Phase 3 & Phase 8 Slurry Walls

GP Aggregates, LLC

West Farm Pit

Subject: Response to May 21, 2025, Inspection Report for West Farm Pit, M-2008-078

Figure 11
Modeled Changes in Groundwater
Conditions - Phase 1, 2, 8 and 3 Pit
Slurry Walls

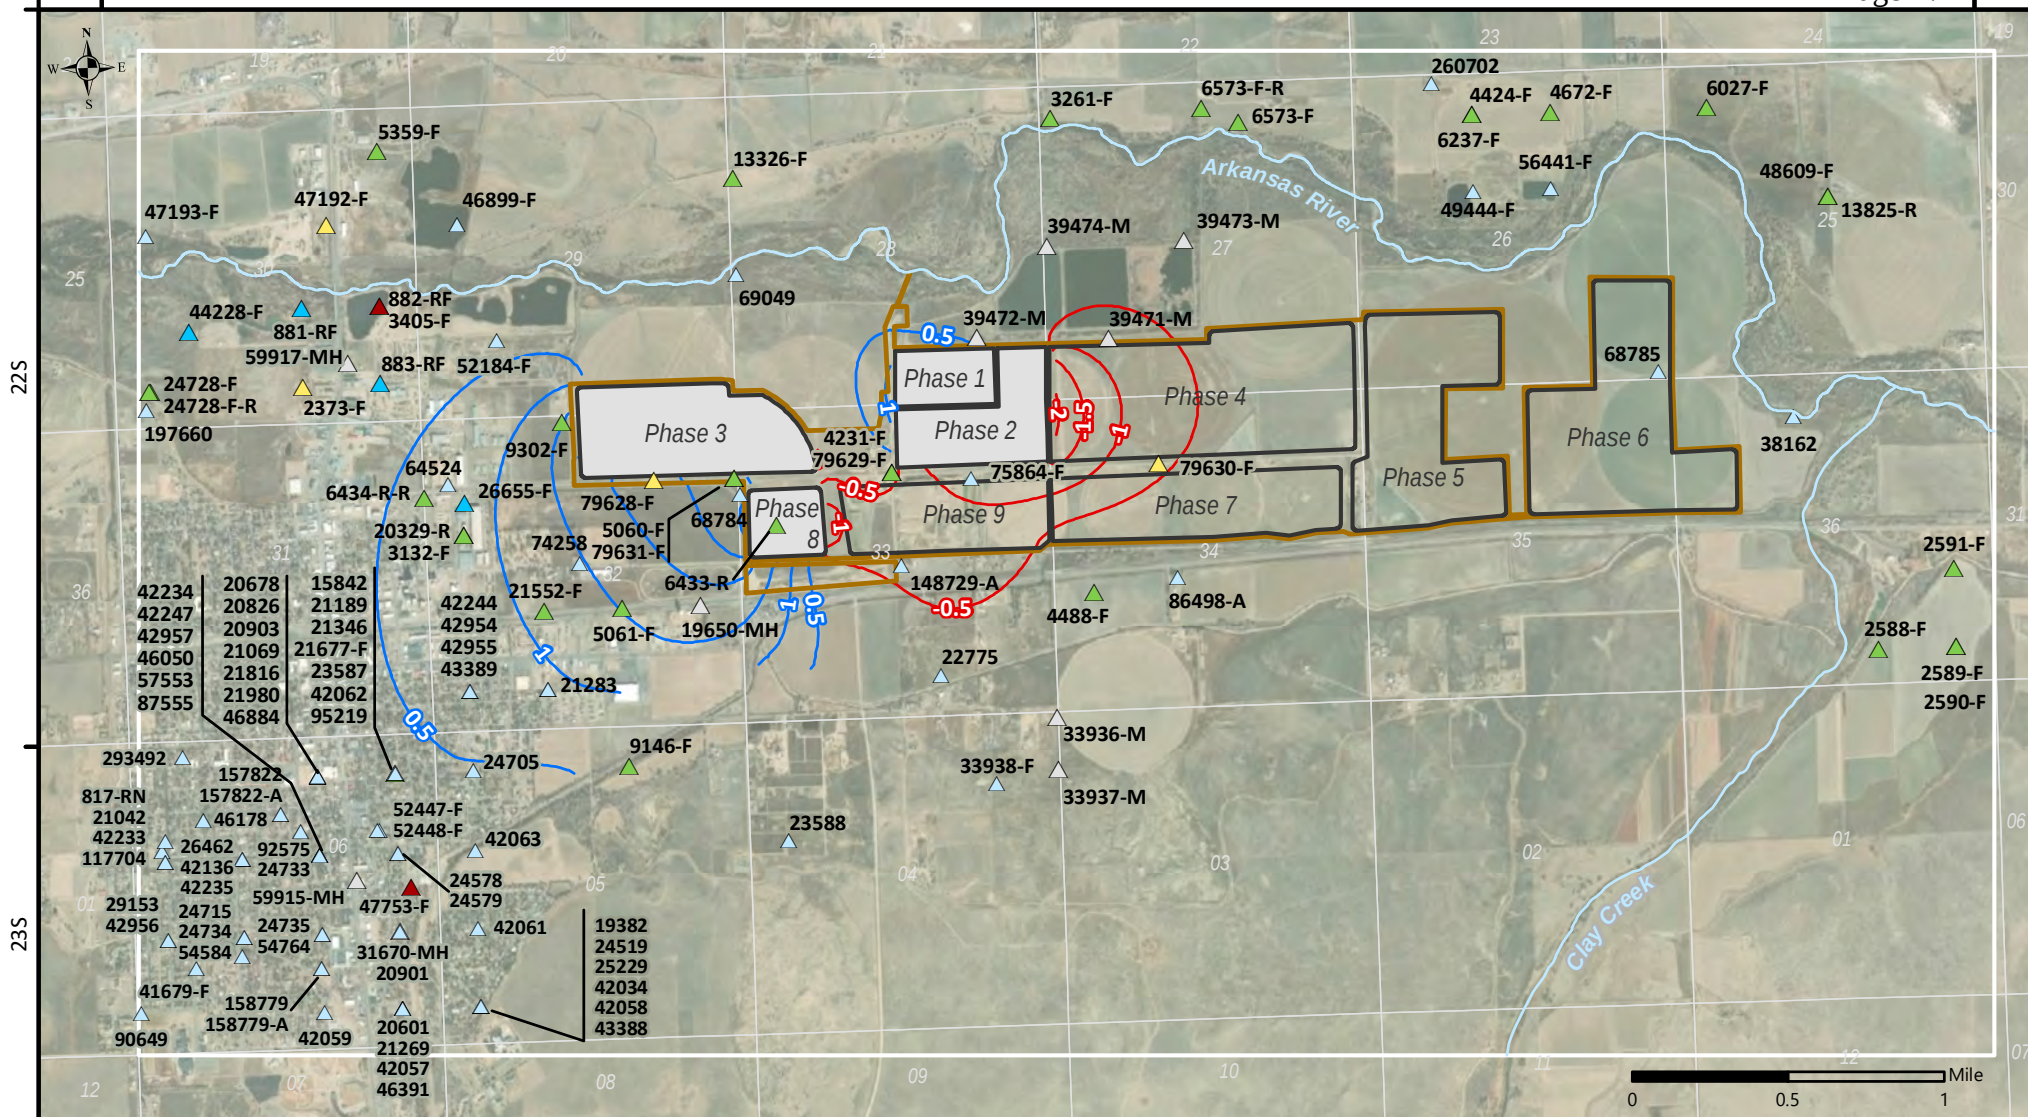
- Mounding on the upgradient side of Phase 3 and Phase 8 as shown in Figure 11 (see, for example, P3-4).
- One to two years to reach a steady state after a slurry wall installation as described on page 2 of the Report (see, for example, P3-3 and P8-1).
